Form 3160-5  
(June 2019)UNITED STATES  
DEPARTMENT OF THE INTERIOR  
BUREAU OF LAND MANAGEMENTFORM APPROVED  
OMB No. 1004-0137  
Expires: October 31, 2021**SUNDRY NOTICES AND REPORTS ON WELLS**  
**Do not use this form for proposals to drill or to re-enter an abandoned well. Use Form 3160-3 (APD) for such proposals.**5. Lease Serial No. **NMNM110835**

8. Well Name and No. **RESOLUTE 12 FED COM/507H**9. API Well No. **3002547602**10. Field and Pool or Exploratory Area  
**WC-025 G-09 S253309P; Upper Wolfcamp**11. Country or Parish, State  
**LEA/NM****12. CHECK THE APPROPRIATE BOX(ES) TO INDICATE NATURE OF NOTICE, REPORT OR OTHER DATA**

EOG respectfully requests an amendment to our approved APD for this well to reflect the following changes:

Resolute 12 Fed Com 744H (FKA 507H)

## WELL LOCATION AND ACREAGE DEDICATION PLAT

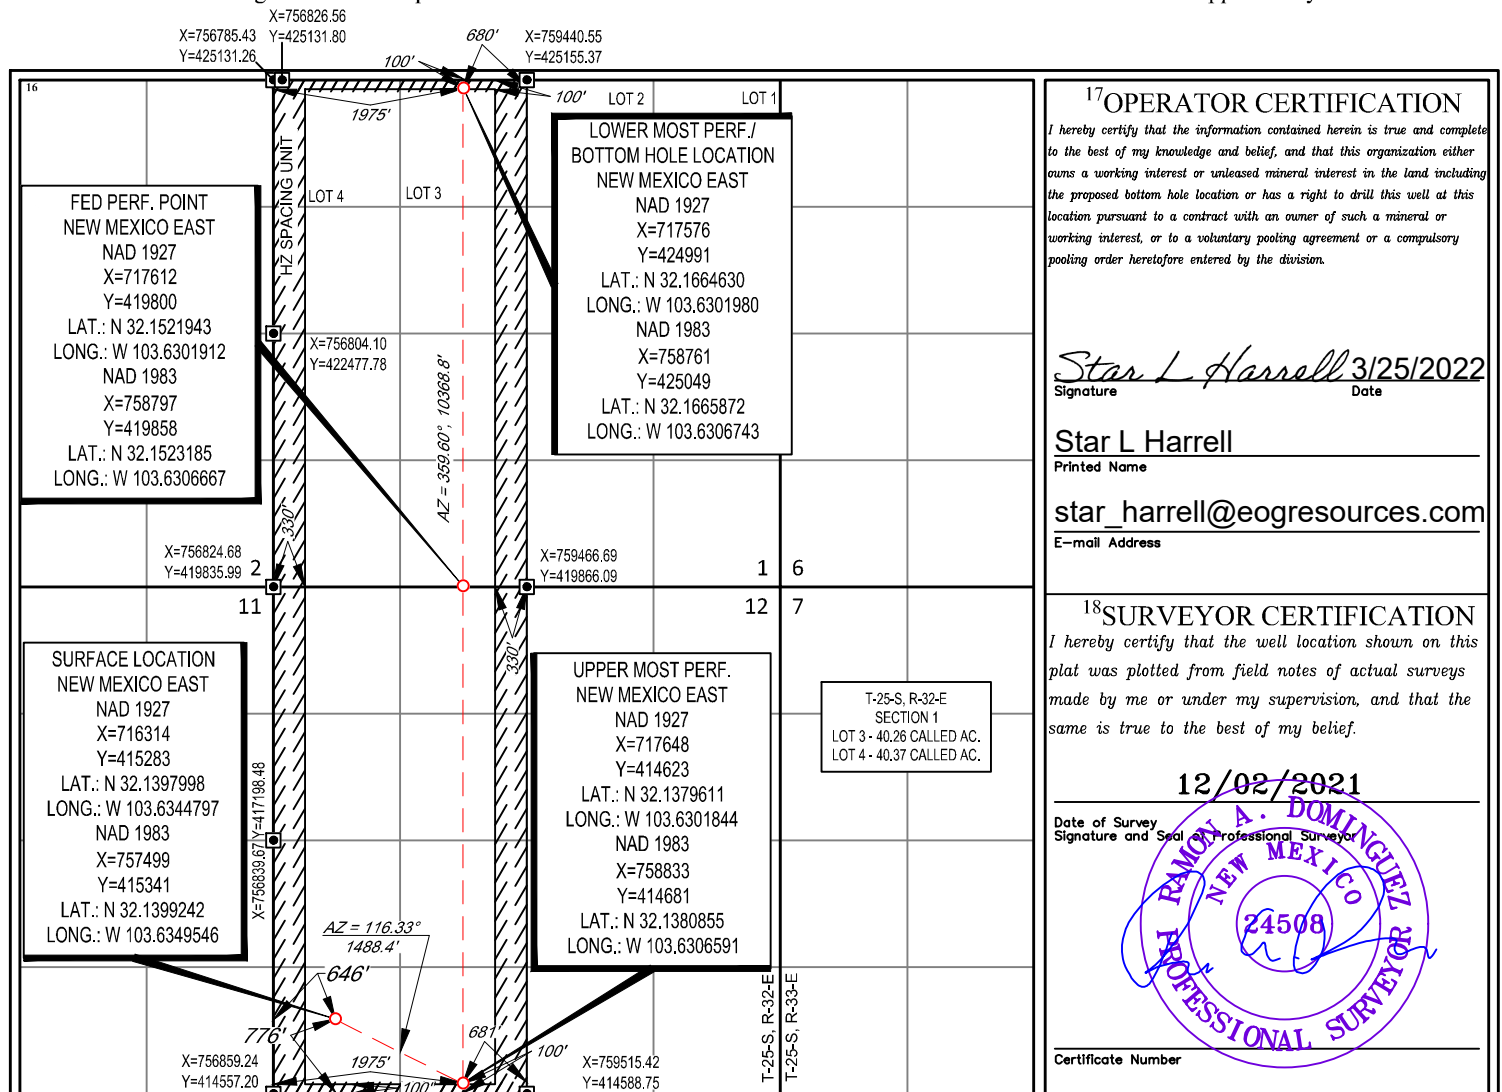
Change SHL from T-25-S, R-32-E, Sec 12, 344' FSL, 1538' FEL, Lea Co., NM, to T-25-S, R-32-E, Sec 12, 776' FSL, 646' FWL, Lea Co., N.M.

Change BHL from T-25-S, R-32-E, Sec 1, 100' FNL, 1830' FEL, Lea Co., NM, to T-25-S, R-32-E, Sec 1, 100' FNL, 1975' FWL, Lea Co., N.M.

UL or lot no.	Section	Township	Range	Lot Idn	Feet from the	North/South line	Feet from the	East/West line	County
<b>M</b>	<b>12</b>	<b>25-S</b>	<b>32-E</b>	<b>-</b>	<b>776'</b>	<b>SOUTH</b>	<b>646'</b>	<b>WEST</b>	<b>LEA</b>

UL or lot no.	Section	Township	Range	Lot Idn	Feet from the	North/South line	Feet from the	East/West line	County
<b>3</b>	<b>1</b>	<b>25-S</b>	<b>32-E</b>	<b>-</b>	<b>100'</b>	<b>NORTH</b>	<b>1975'</b>	<b>WEST</b>	<b>LEA</b>

Proposed Wellbore

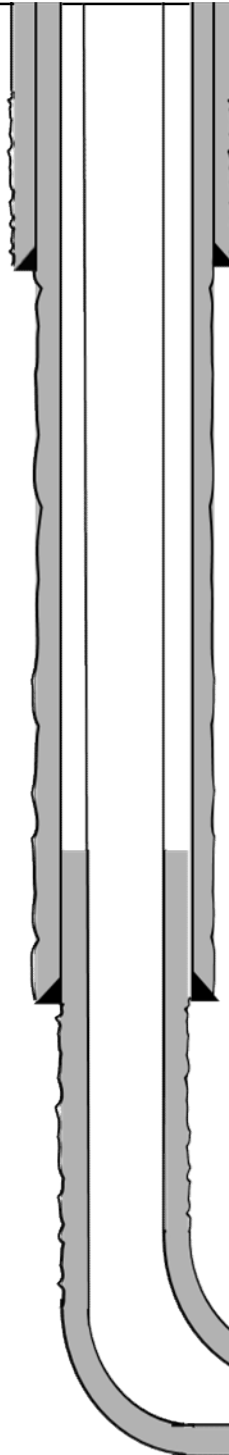
Update casing and cement program to current design.

**Bit Size: 13"**  
10-3/4", 40.5#, J-55, STC,  
@ 0' - 1,070'

**Bit Size: 9-7/8"**  
8-3/4" 38.5#, P110-EC, Vam Sprint-SF,  
@ 0' - 11,200'

**Bit Size: 7-7/8"**  
6", 24#, P110-HP, Eagle SFH SC,  
@ 0' - 23,191'
